PROPOSED SYSTEM MANAGEMENT LEGAL DRAFTING

**EUROPEAN CONNECTION CONDITIONS
(ECC)**

Figure X1 – P_{ref} is the reference **Active Power** to which ΔP is related and. ΔP is the change in **Active Power** output from the **Power Generating Module** or **HVDC Equipment**. f_n is the

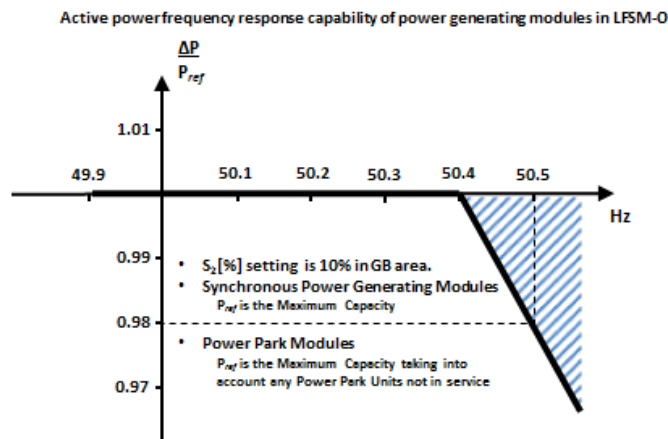
Comment [A72]: Update or duplicate diagram to include DC Converters, DC Connected Power Park Modules and Remote End DC Converters

Figure X2 –Limited Frequency Sensitive Mode – Underfrequency capability of Power Generating Modules and HVDC Equipment.

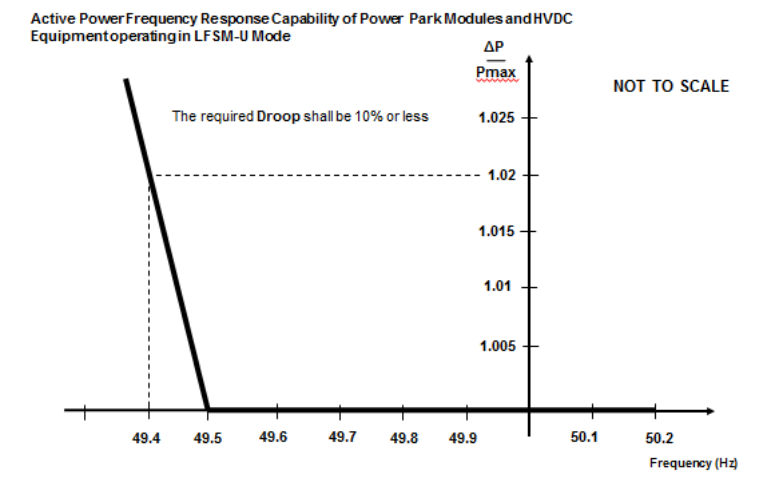
Comment [A77]: This diagram will need to be updated in respect of DC Converters

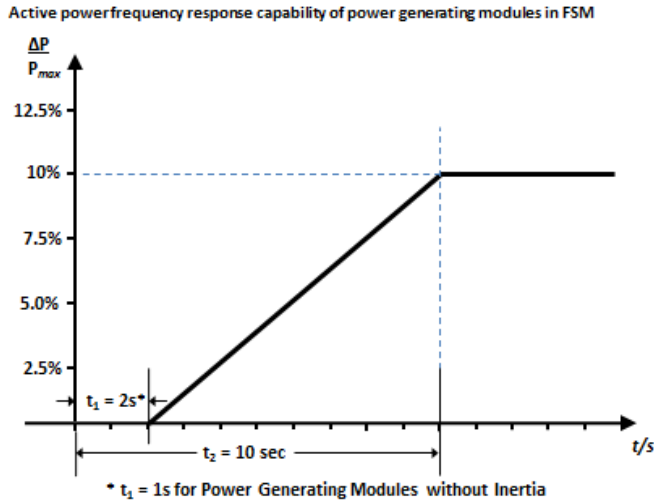
Comment [A81]: This could be simplified with just the parameters inserted and references to t_1 and t_2 removed.

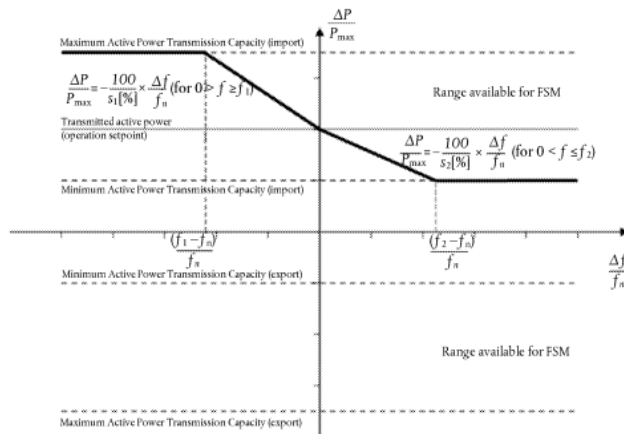
Comment [A82]: Diagram needs to be re-drawn - with GB parameters. There needs to be a reduction in the equations

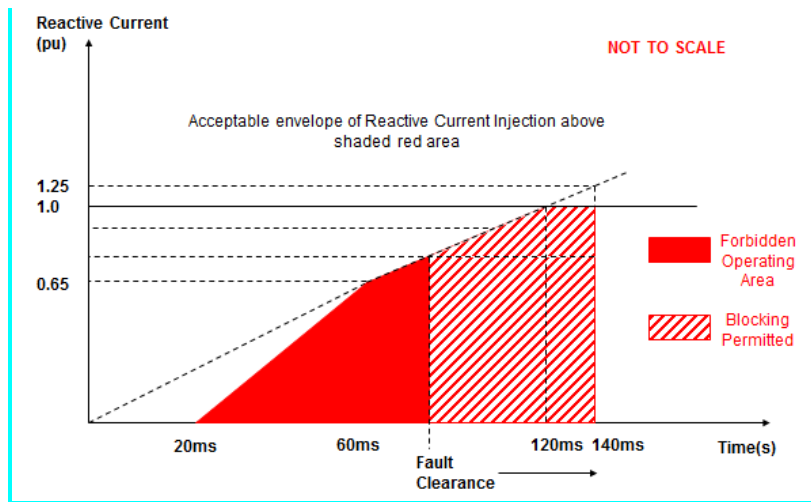
Modify Figure – Superimpose Reactive Current on top of curve – Figure ECC.AX4.1.2(a)

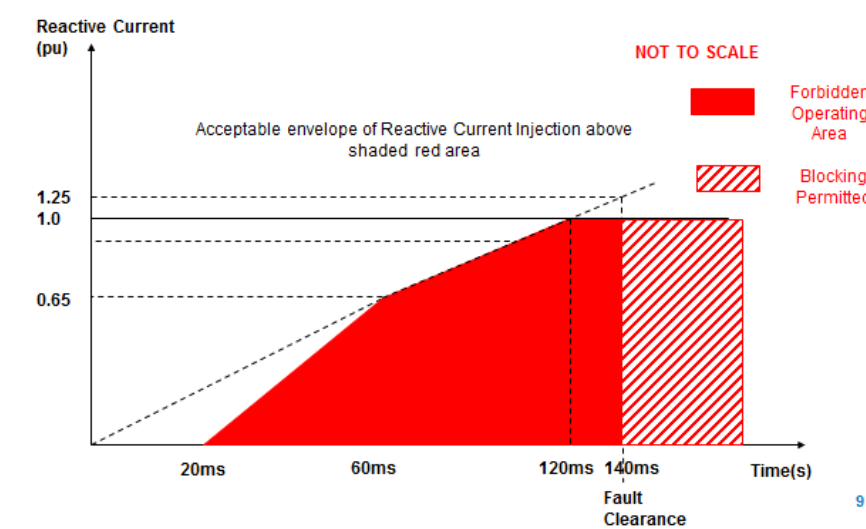
Modify Figure – Superimpose Reactive Current on top of curve—Figure ECC.AX4.1.2(b)

Figure ECC.A.7.2.2b

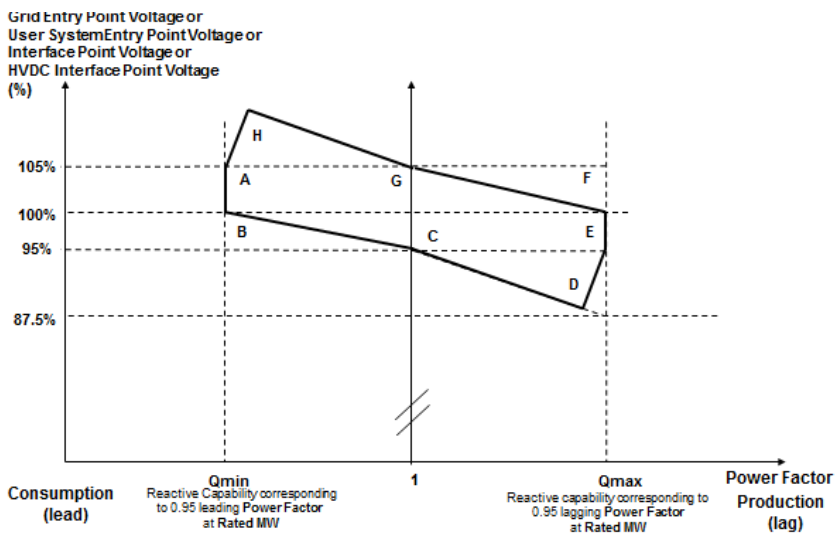
Comment [A125]: This diagram needs updating to include HVDC Interface Point Voltage
